World Forum for Harmonization of Vehicle Regulations**Working Party on Automated/Autonomous and Connected Vehicles*****Fifth session**

Motorcycle braking:**UN Regulation No. 78****Proposal for a new 05 series of amendments to UN
Regulation No. 78 (Motorcycle braking)****Submitted by the expert from the International Motorcycle
Manufacturers Association****

Model B

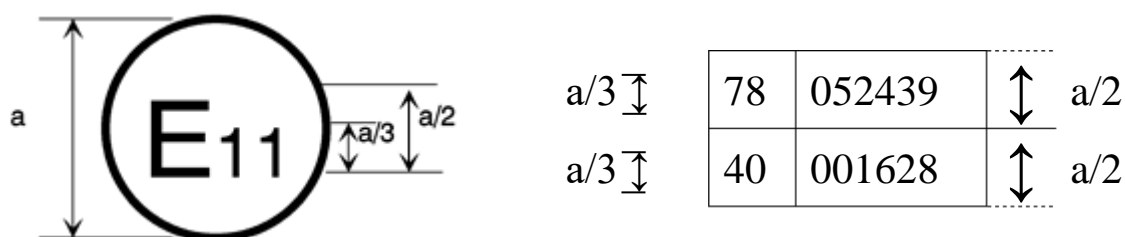
The above approval mark affixed to a vehicle shows that the vehicle type concerned has been approved in the United Kingdom (E 11) pursuant to UN Regulations Nos. 78 and 40. The first two digits of the approval numbers indicate that, at the dates when the respective approvals were granted, UN Regulation No. 78 included the ~~04~~ **05** series of amendments but UN Regulation No. 40 was still in its original form."
